TOWN PLANNING REPORT

Application under Section 4.55(1A) of the Environmental Planning and Assessment Act 1979 to modify Development Consent No. 10.2010.547.3

Lot 10 DP 1200712
No. 111 Bangalow Road, Byron Bay

18 August 2022
Revision A

Proposed Sewer Connection Plan

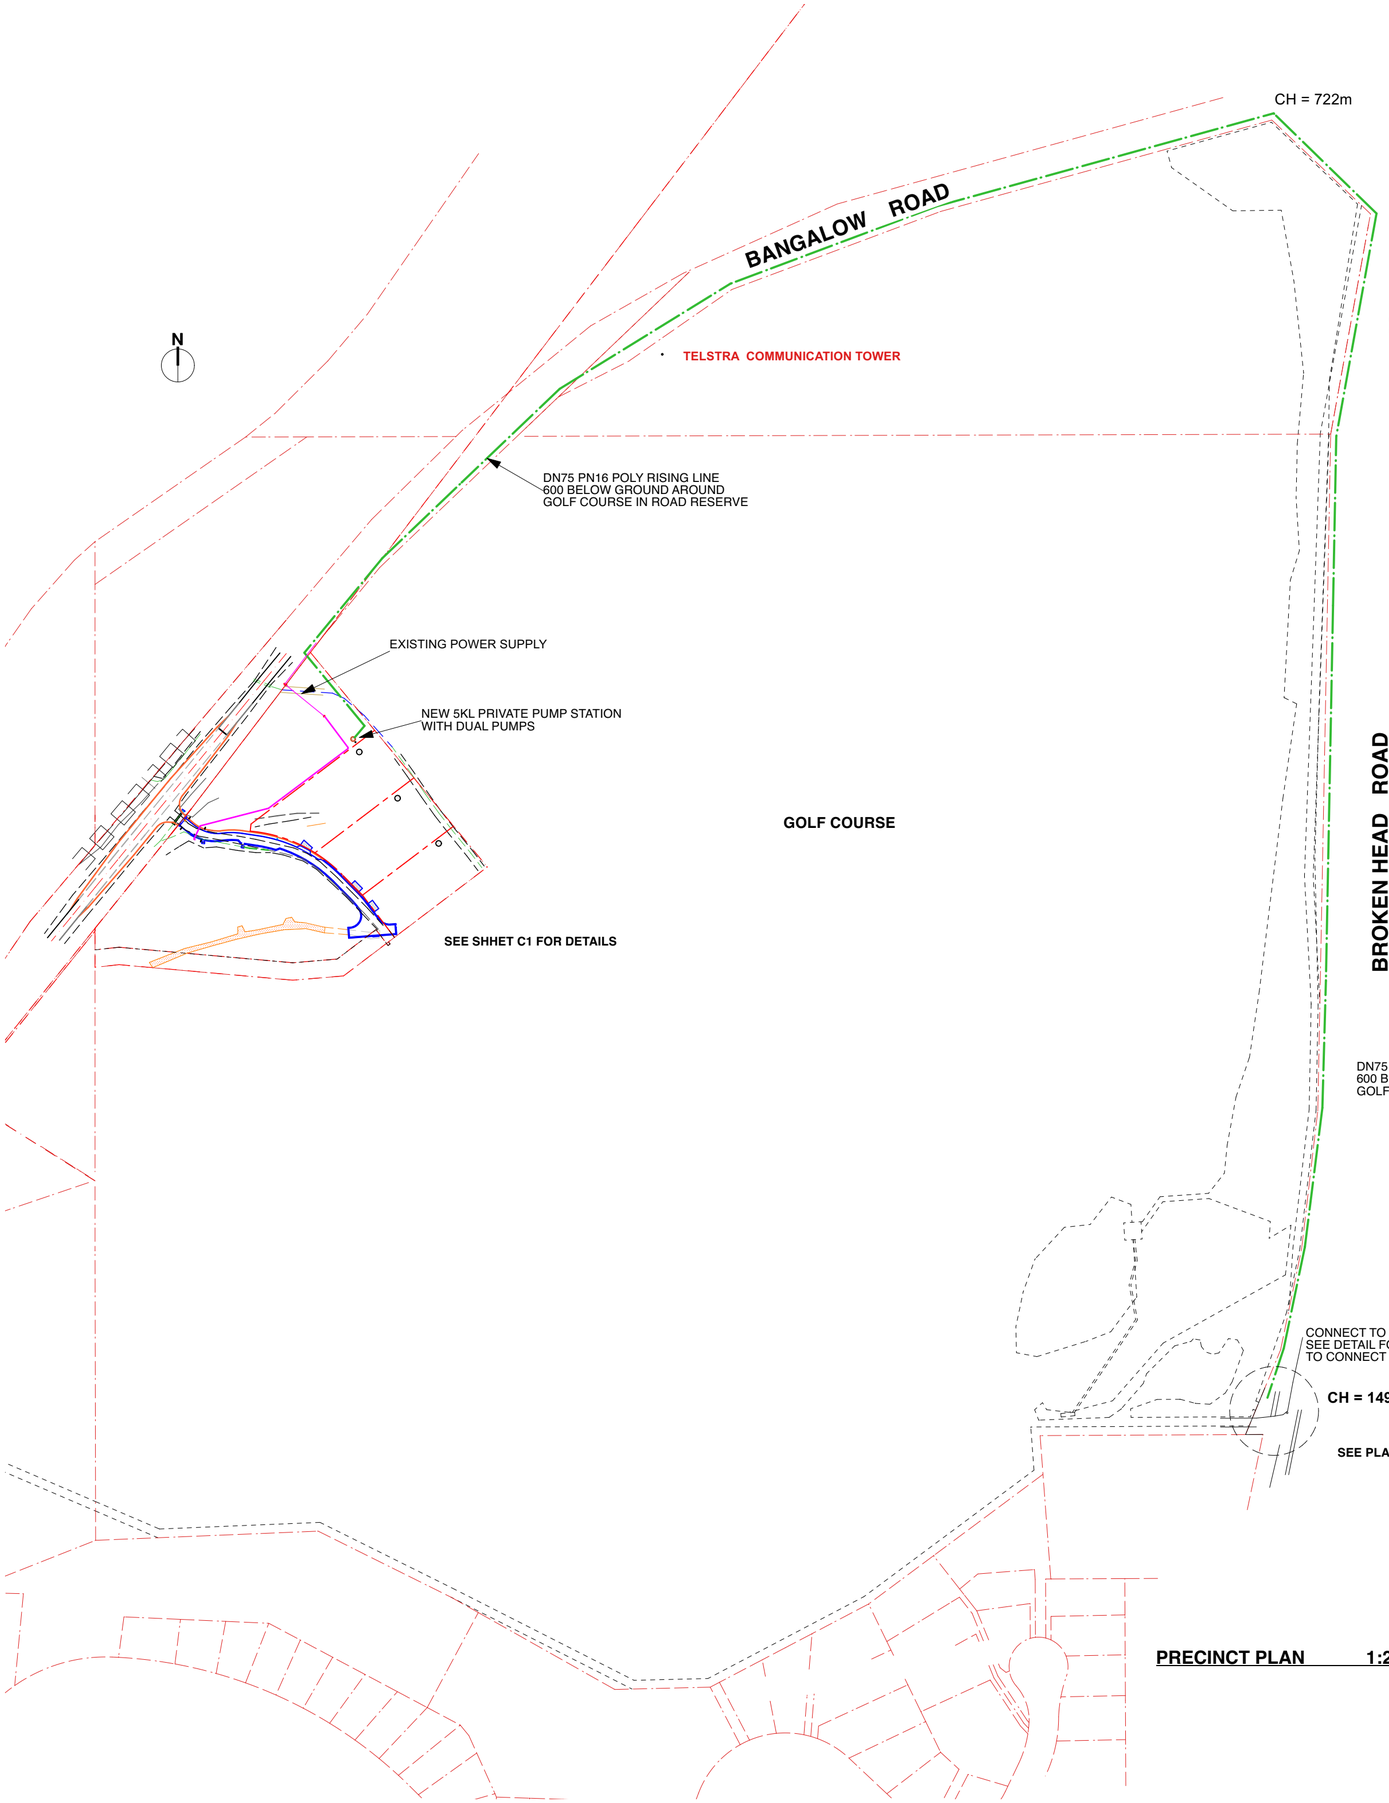
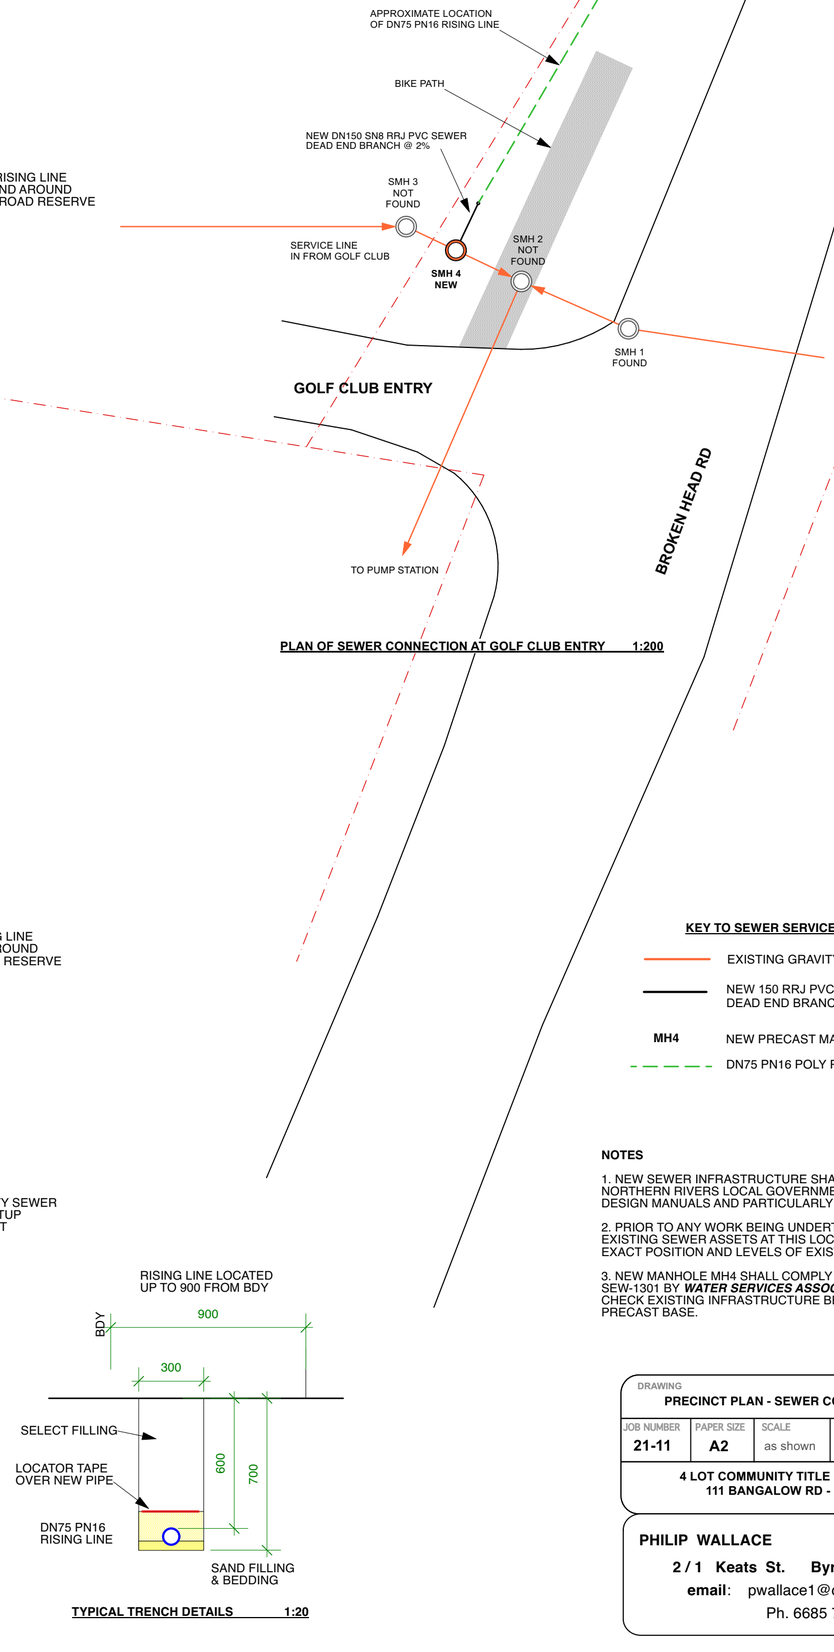
Modify conditions of consent including reference to a plan showing a new alignment for the proposed sewer connection line, removal of the requirement for a sewer easement, clarification of the maintenance responsibilities for the sewer line and amendment to the timing of submission of an acoustic report

It is proposed to substitute Drawing C1A Issue E, with a revised plan, Drawing C1A Issue G, as attached to this report. This modified plan has been prepared after attempts to locate the required sewer connection line through the adjacent Byron Bay Golf Club land failed. It is now proposed to run the sewer connection line within the road reserves adjacent to Bangalow Road and Broken Head Road per the attached plan.

Plan	Name	Author	Date
C1A Issue G	Precinct Plan – Sewer Connection	Philip Wallace Consulting Engineers	02-2022
